# Recall Campaign Bulletin

Campaign No. 2023010005, January 2023

Revision C 04/30/2025

## **Check Sliding Roof Bonding**

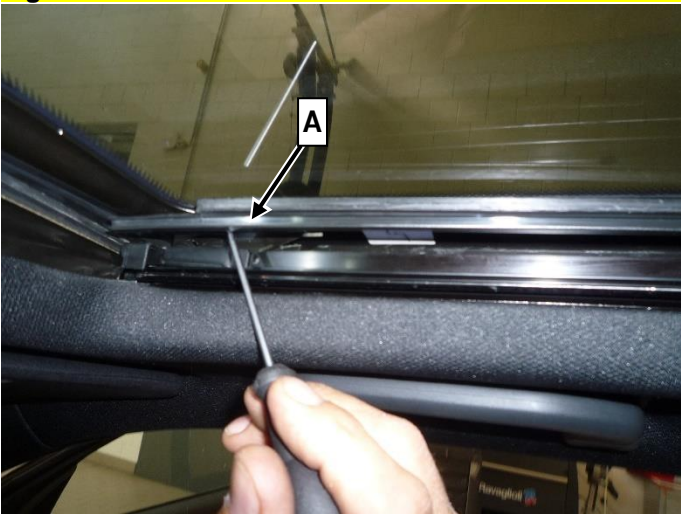
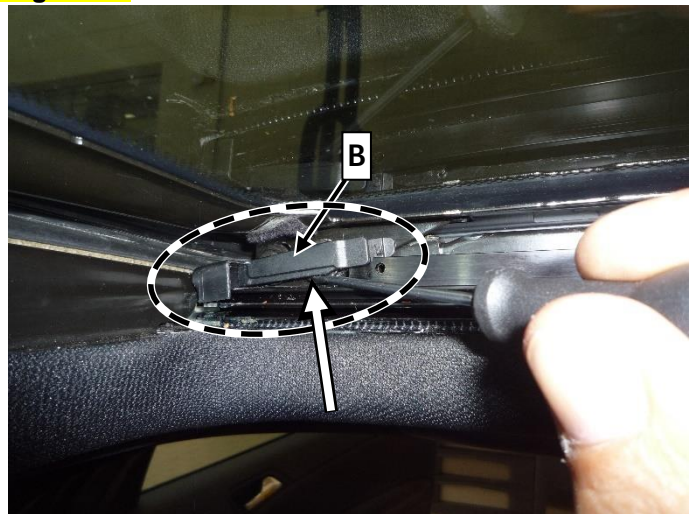
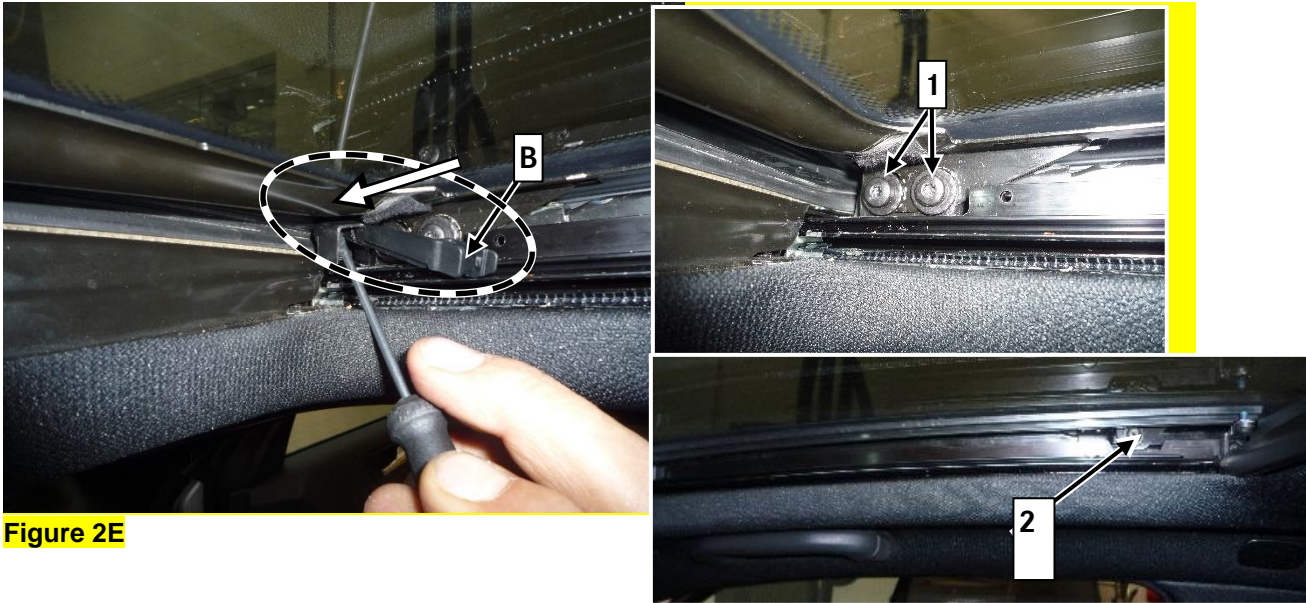
- Information about **TIPS case** creation added.
- Note and figures 2A to 2E in **Check/Test Procedure A** added.

- i** If the emergency opening function of the panoramic sliding sunroof is **not** operational (**Figure 2**), remove the pleated rubber on the **right and left**.  
 To do so, pull out the pleated rubber upwards (**Figure 2A**) and pull it out of the front guide (**Figure 2B**) in the direction of the arrow. Then tilt the rail (**Figure 2C, A**) out to the front by hand and remove the holder (**Figure 2D, B**). To remove the holder, first unclip it at the rear with a screwdriver and press it upwards (**Figure 2D, B**). Then press the holder to the front in the direction of the arrow (**Figure 2E, B**) and take it out.

Now on both sides loosen the front two glass panel screws (**Figure 2E, 1**) and center glass panel screws (**Figure 2E, 2**) and lift the sliding sunroof by hand just enough to be able to read off the production date.

- Nm** Screws of tilting/sliding roof panel: **5Nm**.

Figure 4

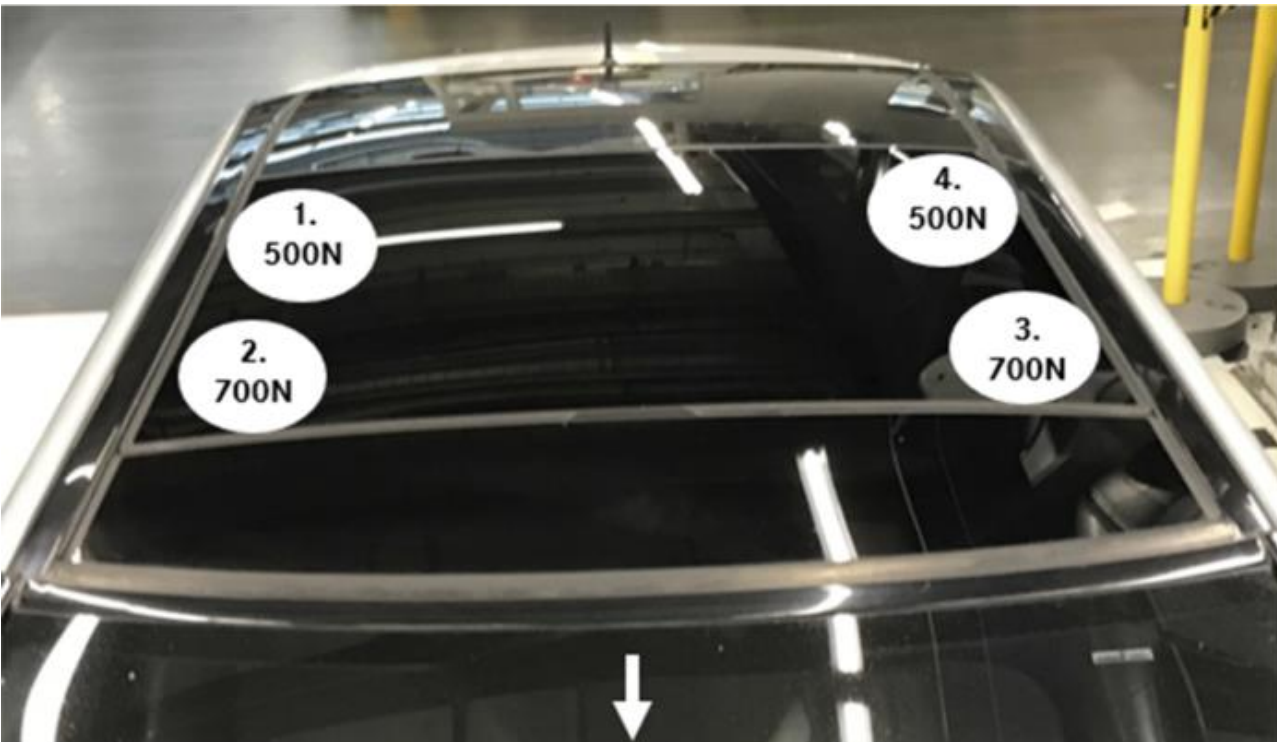
- i** The hanging scale **must** be adjusted as per the operating instructions before use.
    - i** Specified force **500N /700N** (Figure 4).
    - i** Before the start of the measurement, the "(auto) hold function" of the hanging scale (see operating instructions) **must** be deactivated.

- No** "hold function" may be activated so that the current tractive force is always displayed.
    - i** Position suction cup tool at 4 positions in the sequence **1, 2, 3, 4:** (Figure 4).
